AMENDMENT:
PROPOSED EXTERNAL WORKS:
 Carport, Balcony + Staircase
 12.11.2019

PROPOSED ALTERATIONS AND ADDITIONS
 LOT 774 & DP1119757 - DIGGINGS TOE THREDBO - NSW

DA010

JAN 2018
 DWG-964-THR-PREL-00 (9.1)

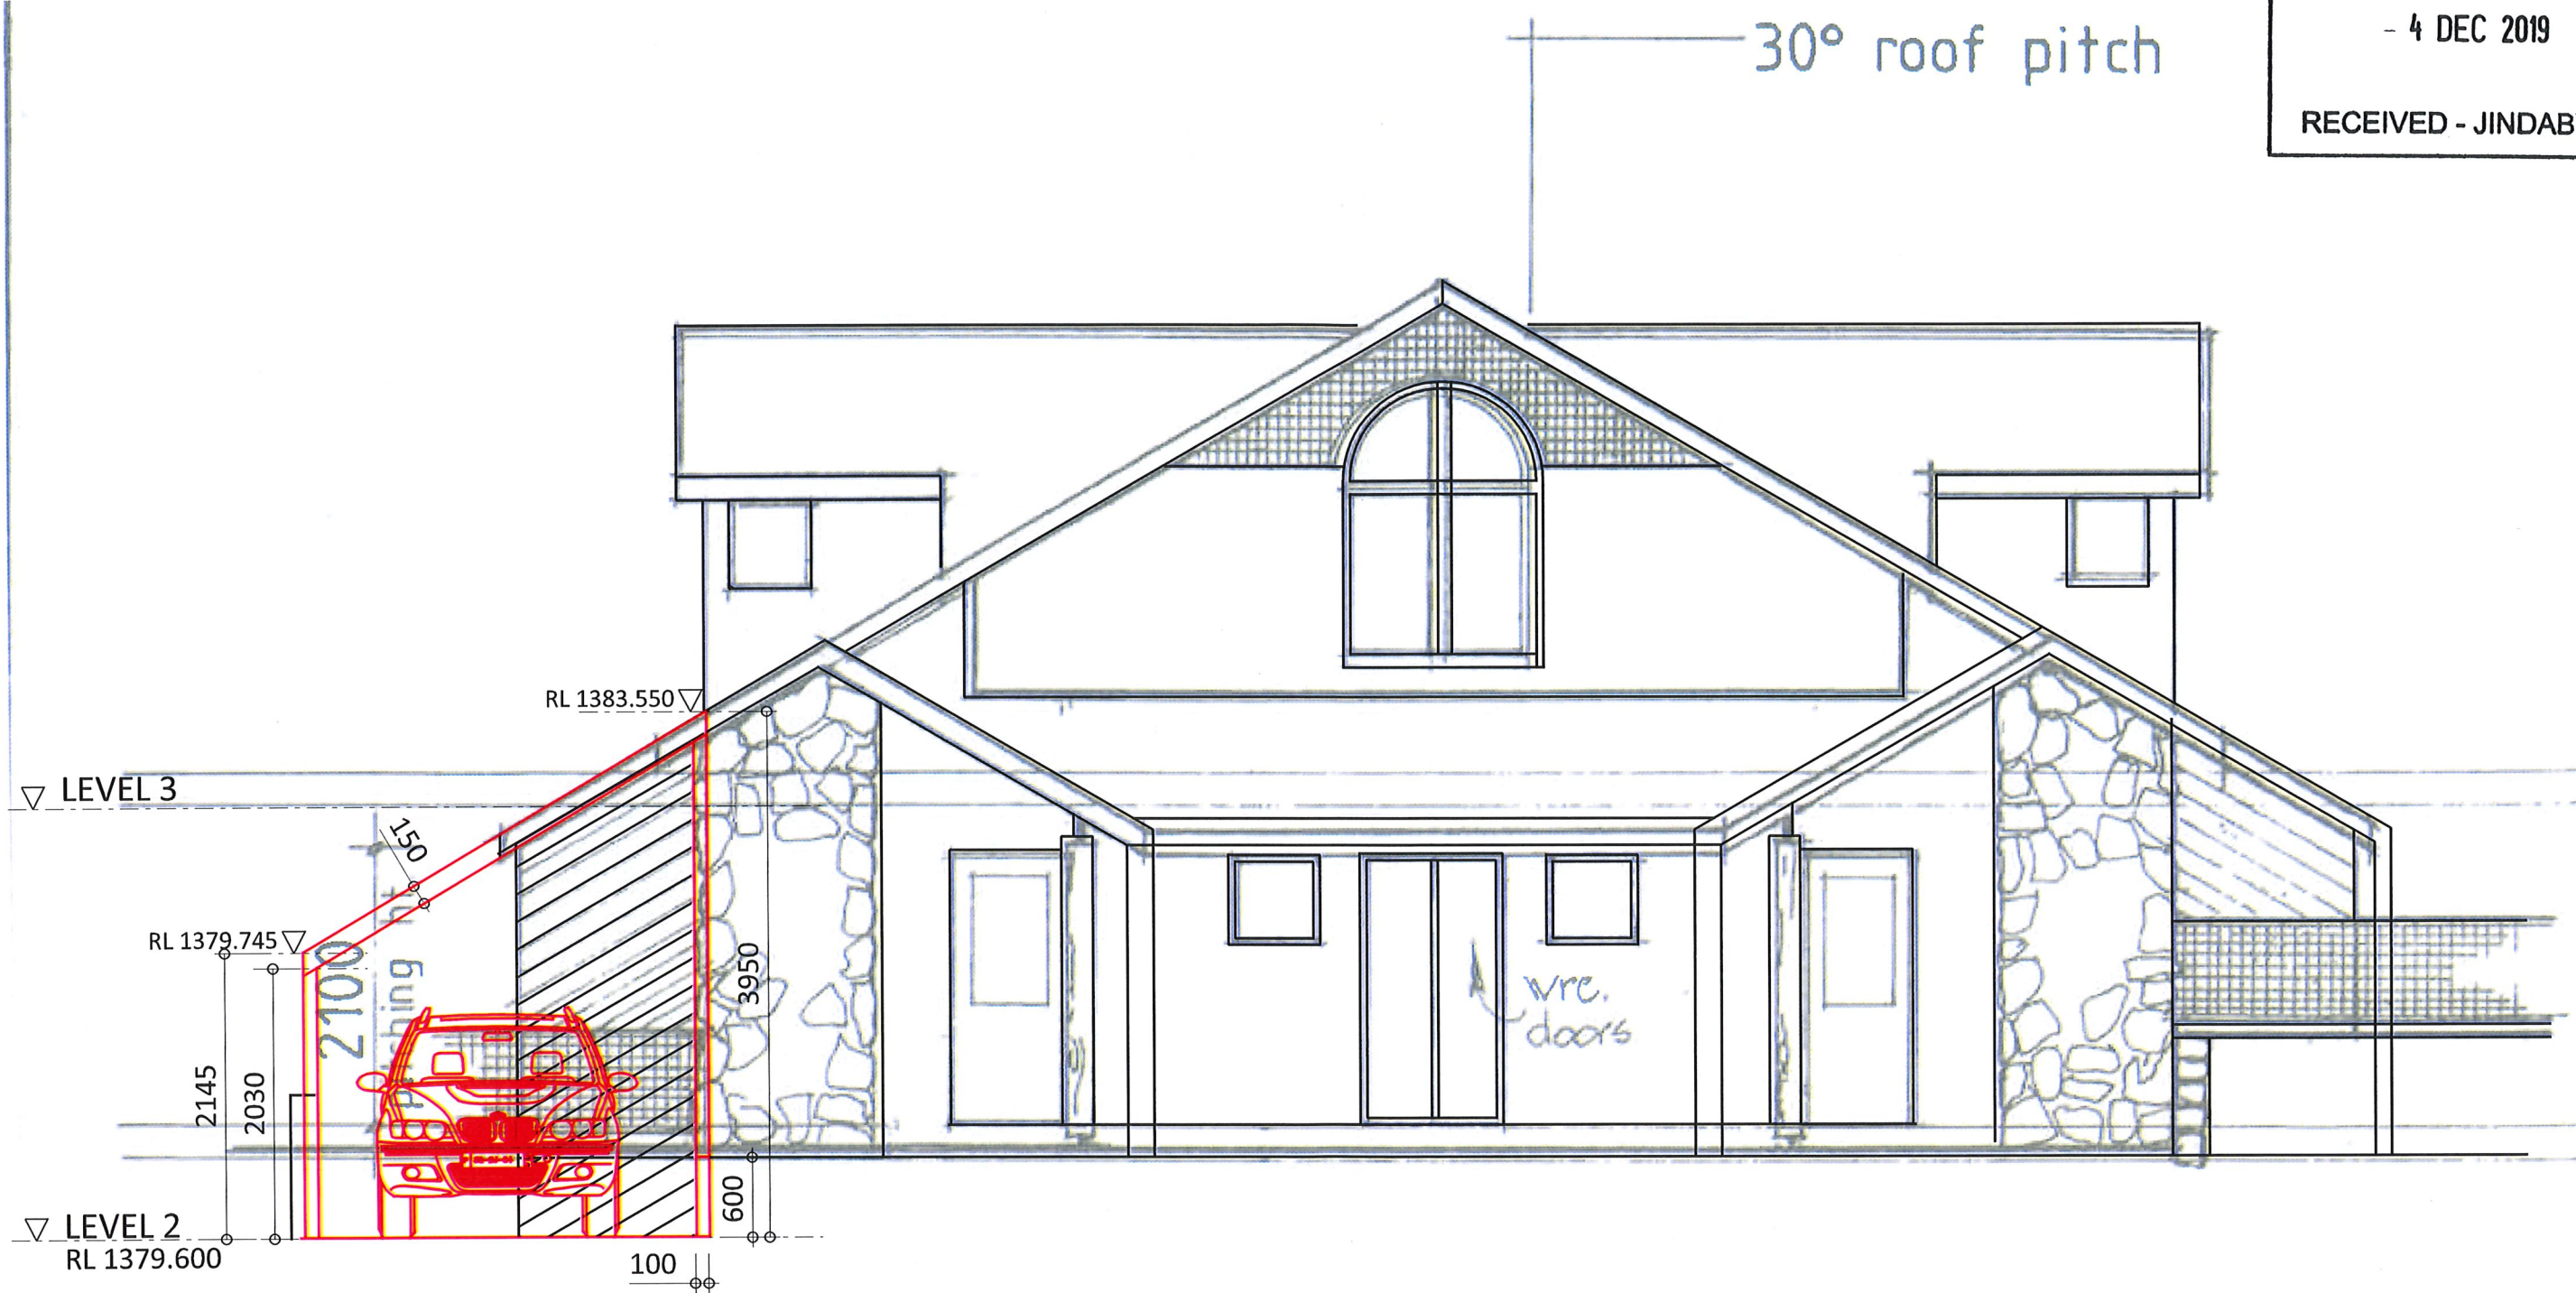
AMENDMENT:
 9.1-4-7-18

1. CONSTRUCTION ACCESS STAIR ADDED TO SITE PLAN
2. ELEVATION ALTERED TO ADD COLOUR AND JOINT DIRECTION
3. SECTION CHANGED- NOTE ADDED RE-NO WORK ON NEIGHBOUR PROPERTY
4. EXTERIOR FINISHES DRAWING ADDED
